**METROPOLITAN GOVERNMENT OF NASHVILLE AND DAVIDSON COUNTY**

**STAFF RECOMMENDATION**  
**1226 4<sup>th</sup> Avenue North**  
**May 18, 2016**

**Application:** New construction - infill  
**District:** Germantown Historic Preservation Zoning Overlay  
**Council District:** 19  
**Map and Parcel Number:** 08209032200  
**Applicant:** Barry Brechak  
**Project Lead:** Sean Alexander, sean.alexander@nashville.gov

Figure 5: Proposed setbacks compared to existing setback. Solid green line indicates existing setbacks and dashed blue line is approximate proposed setback.

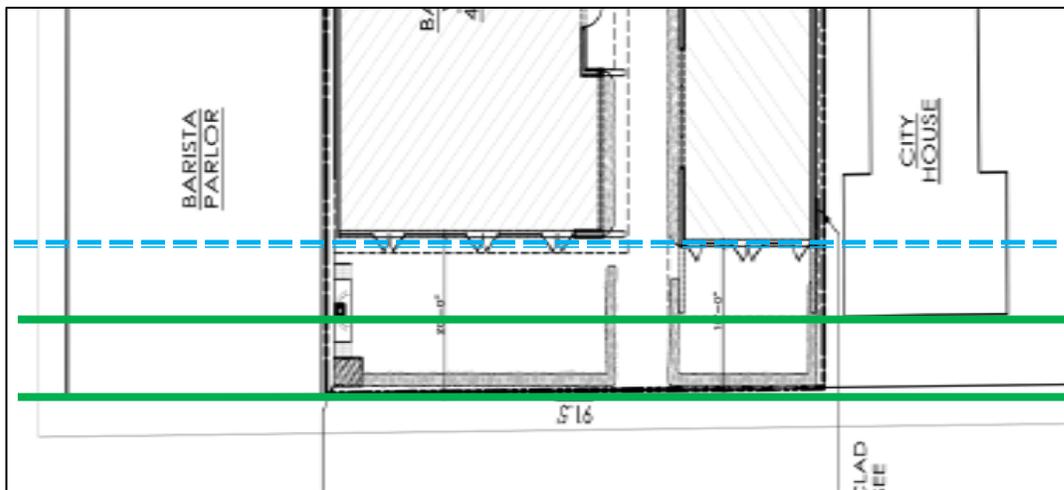
Staff finds that this setback would contrast greatly with the adjacent building, which sits at the front edge of the property. The building to the right will sit eighteen feet (18') back from the sidewalk, double the setback of the historic house to the right. Although the right building will have a nine-foot (9') deep cantilevered eave extending toward the front, Staff finds that the perceived setback will be much deeper than the adjacent building. Staff finds that the new buildings' setbacks are not appropriate for the surrounding context. The project does not meet section 3.1.1 and 3.1.4 of “general principles” which states that buildings should be sited in a way that is appropriate for their context and the context they create.

chimney. No other front fireplace/chimneys exist in the neighborhood. The design guidelines also require a “spatial separation’ from the sidewalk in the case of deep setbacks. In this case, the proposal is for a deep setback like what is seen with residential buildings; however, the setback is greater than what is seen within the context and the area does not create a spatial separation but instead creates a public space with use of a patio, which is more appropriate for a commercial building with a shallower setback. The design guidelines encourage front seating and landscaping for commercial buildings to enliven the streetscape but it also states that it is important to avoid arbitrary establishment of setbacks resulting in “haphazard building placement and a resulting interruption or absence of visual order within the District.” Staff finds the depth of the proposed patios and the fireplace feature individually are not in keeping with the character of the surrounding context and that combined with the deep setback does not meet the design guidelines for either residential or commercial uses.

**GROUND FLOOR PLAN**

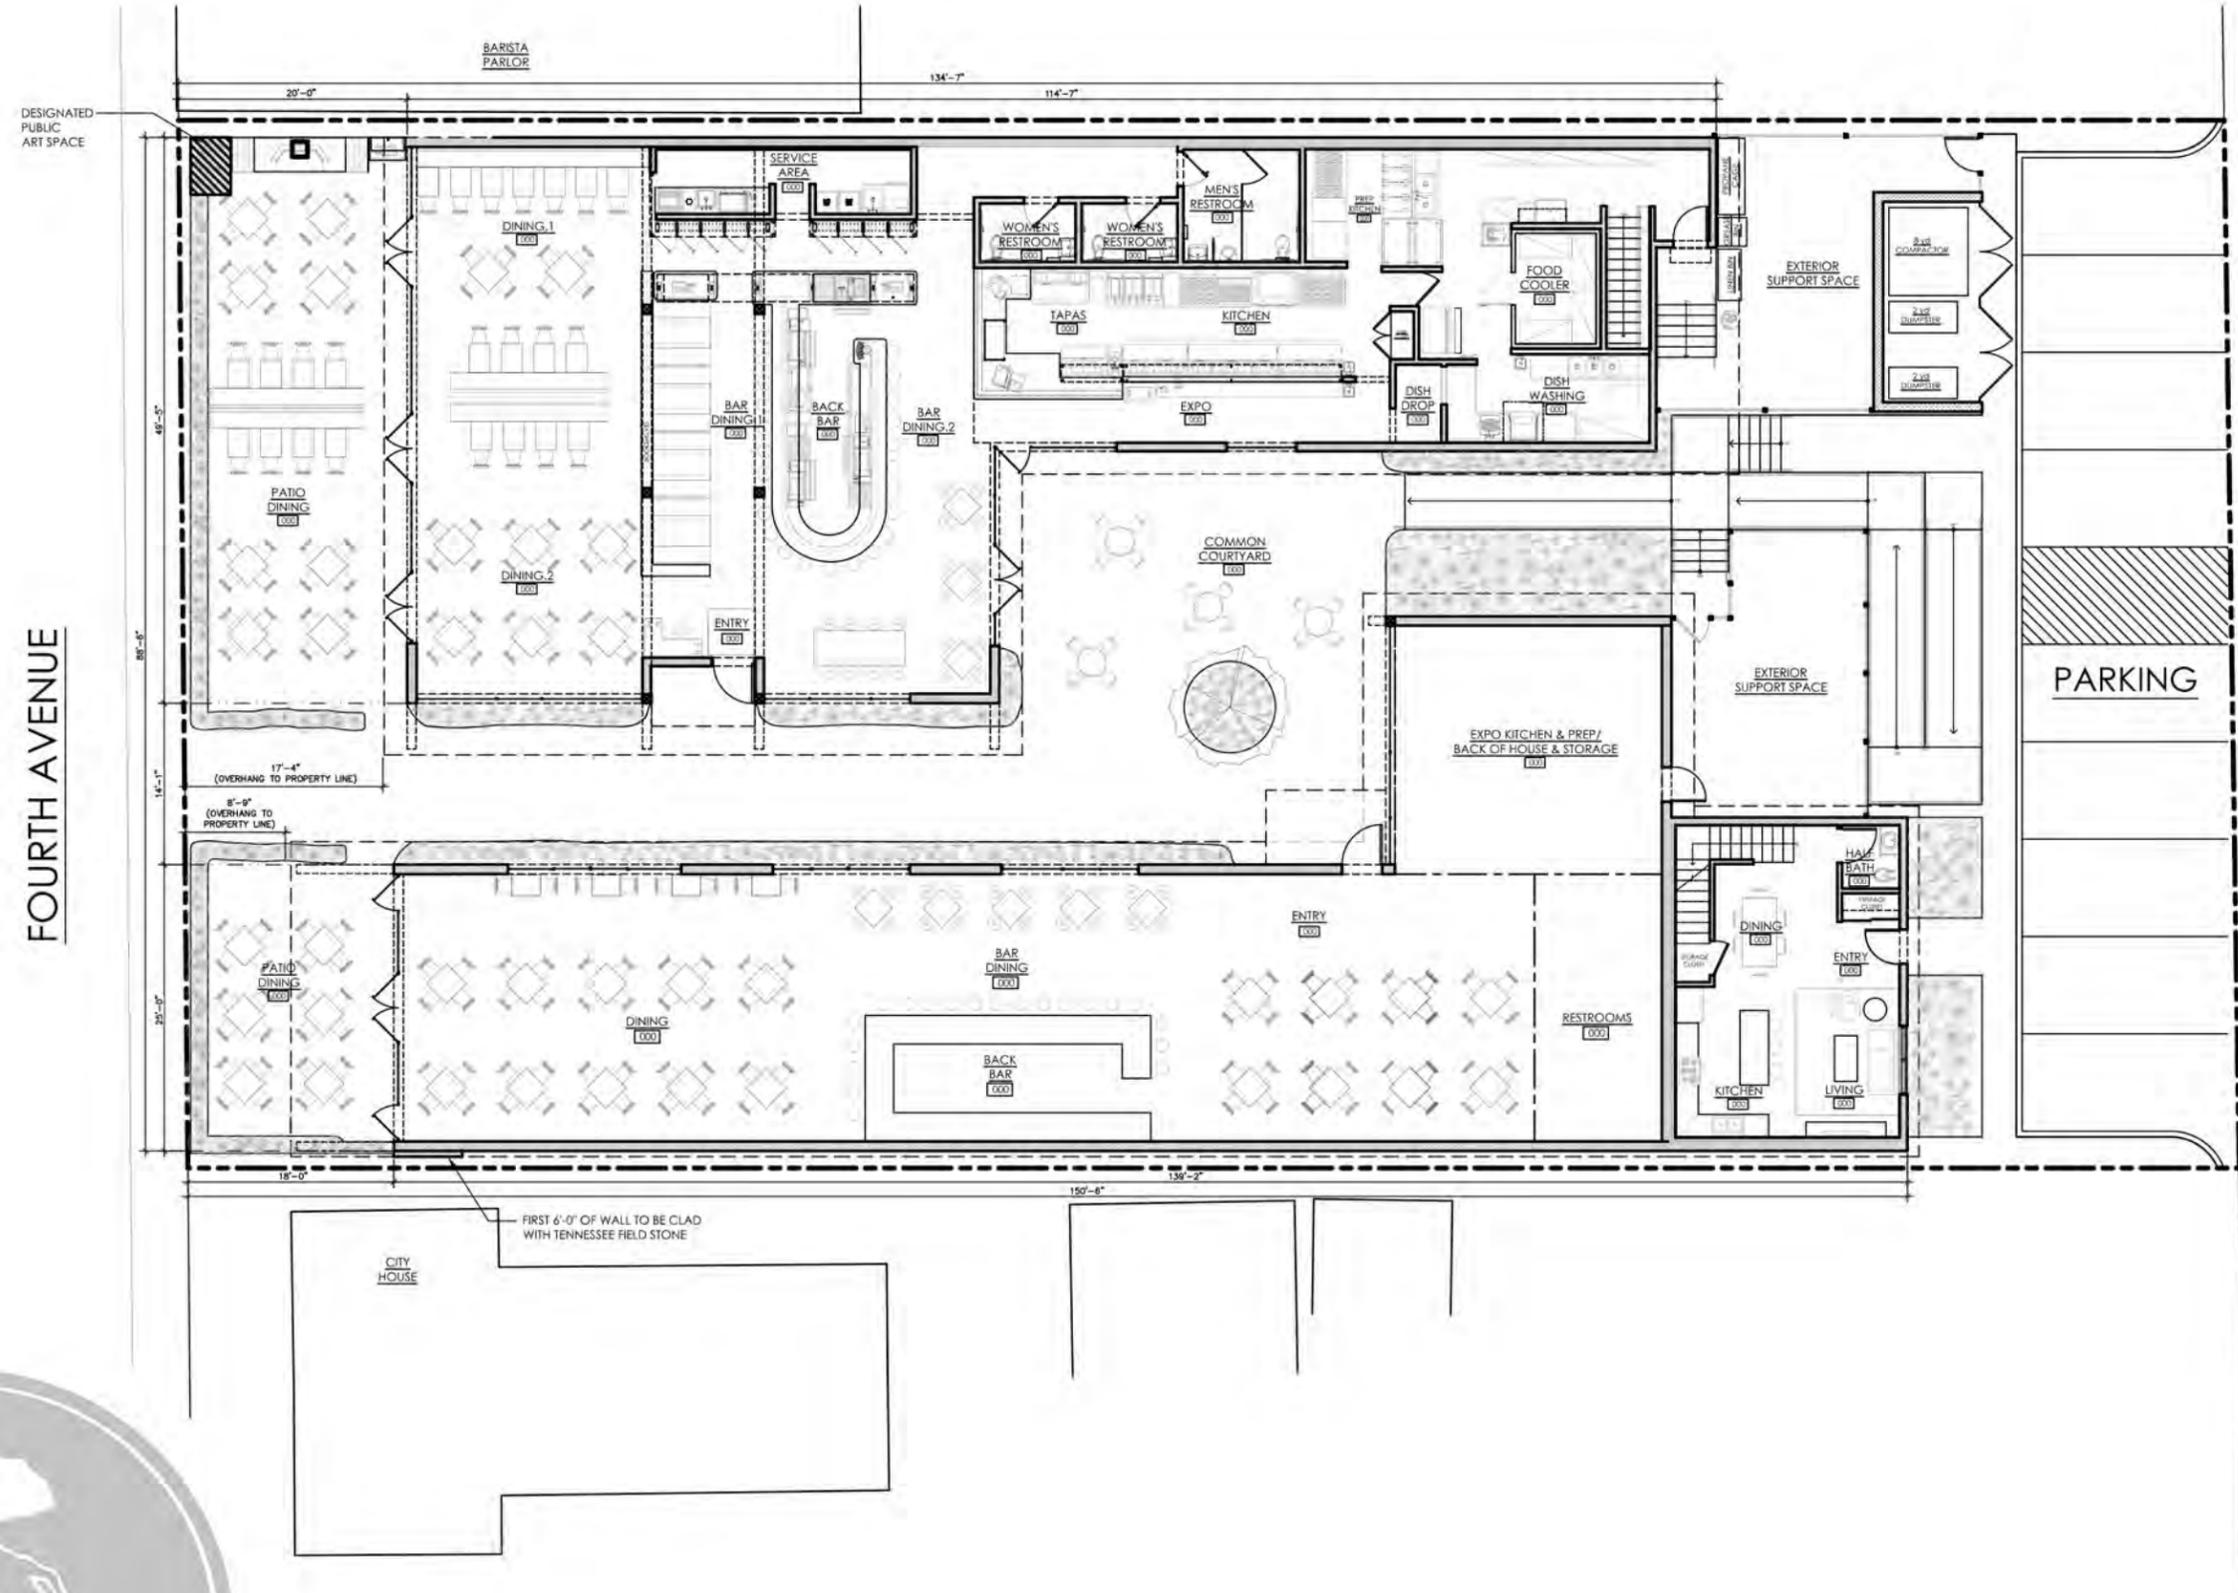
Orientation: The primary entrances to the new buildings will be from the sides, accessed through the central walkway. The front facades will be separated from the sidewalk by front patios enclosed by hedges, further reducing the prominence of the doors on the front façade. Staff finds that that this does not meet guideline 3.2.3, which requires buildings to have primary entrances oriented toward the street.

**FRONT ELEVATION @ PATIO**

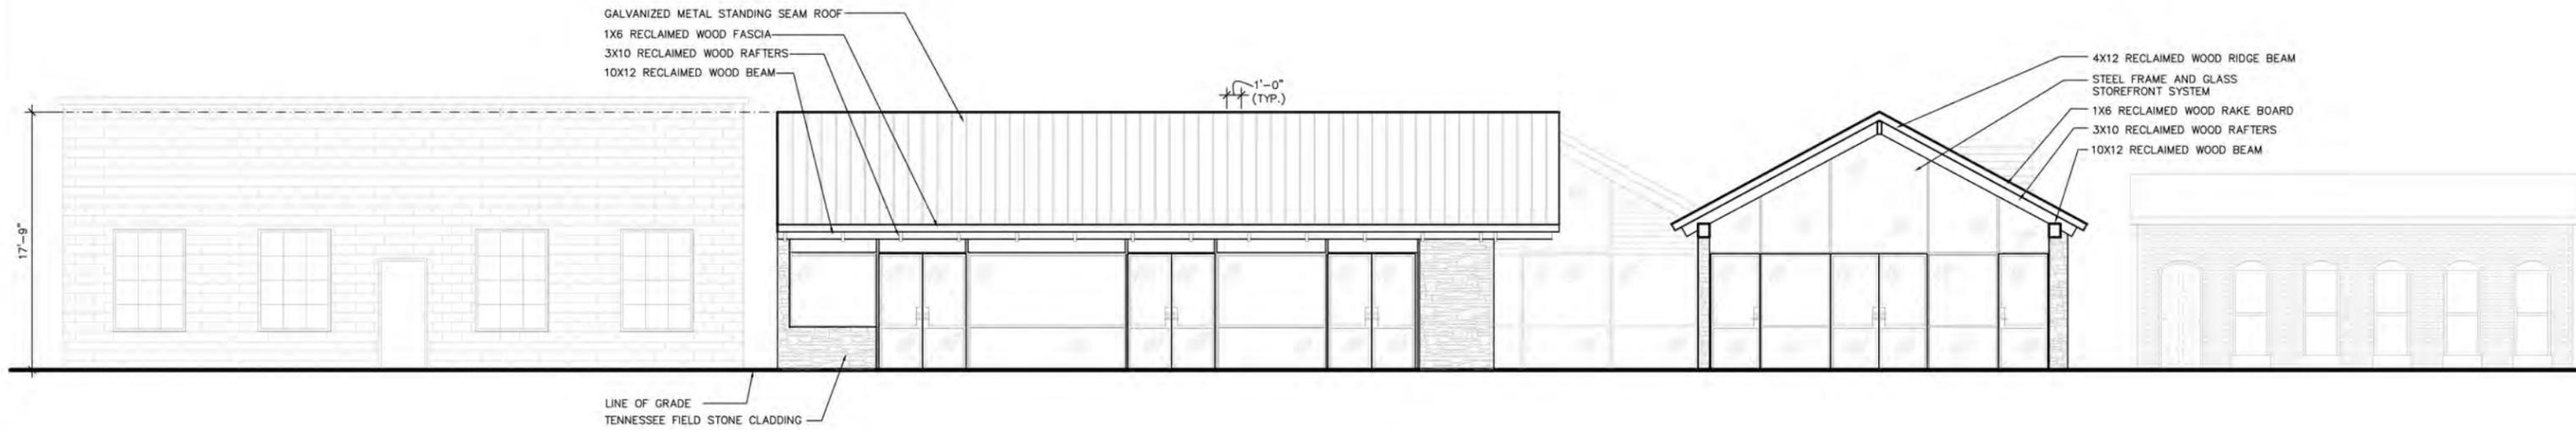
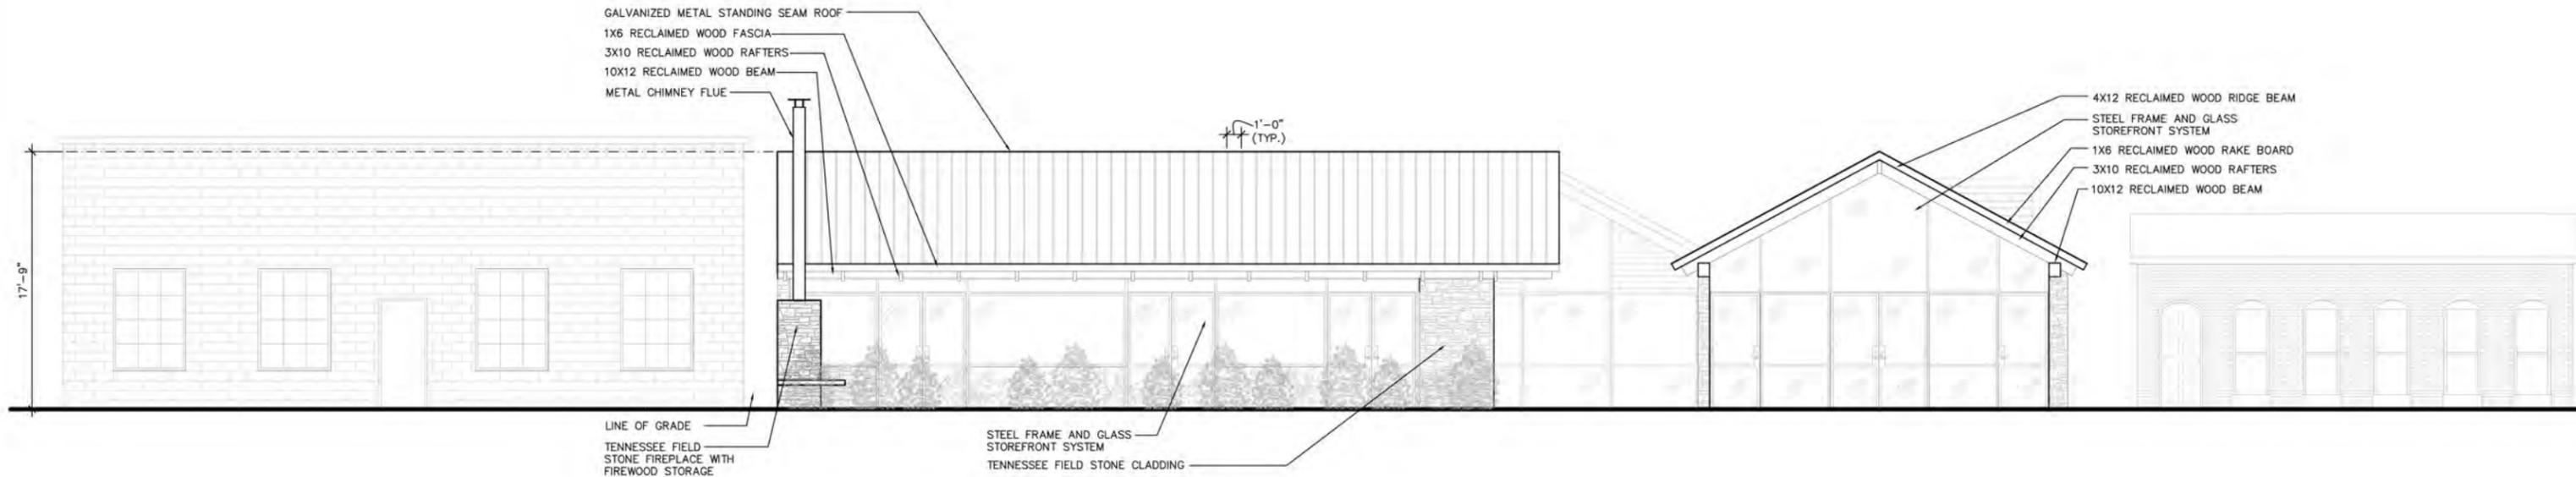
Façade Articulation: The storefronts are primarily glass and will not have a balance of walls and openings that is typical of historic buildings in the area. The design guidelines call for design techniques that avoid large expanses of unbroken façade plans and/or materials in two sections of the design guidelines. Staff finds that the glass front facades without breaks by solid features do not meet section 3.3.2 for materials and 3.2.4.2 for façade articulation in the design guidelines. In addition, the design guidelines for windows assumes buildings with “punched openings” by stating that windows will reviewed for the dimensional depth of rails, stiles, mullions, muntins, divided lights, stills, casing or trim (section 3.5).

Materials: The front facades of the two buildings will be primarily glass storefront systems with metal framing. The roof will be galvanized standing seam metal. Staff finds the roof material to be appropriate and to meet guideline 3.3.1. The proposed front patio fireplace and the lateral walls of the storefront will be stacked fieldstone, with the walls switching to concrete block as they continue back. The roof structural elements, including beams, rafters, and fascia, will be reclaimed wood.

Guideline 3.3.1 requires that new materials meet the Secretary of Interior Standards. Standard #9 for rehabilitation states that new construction should include materials that are compatible with historic materials. While some types of wood and masonry cladding can be appropriate for new construction, Staff finds that the details and texture of stacked stone and rough wood are not compatible with the finishes on surrounding buildings which are more typically brick with milled and painted wood and so do not meet guideline 3.3.1. Furthermore, as these materials are not typical of an urban commercial building, they do not meet guideline 3.1 (Secretary of Interior Standard #3) as it gives the building “a false sense of being in an alternate time and place.”
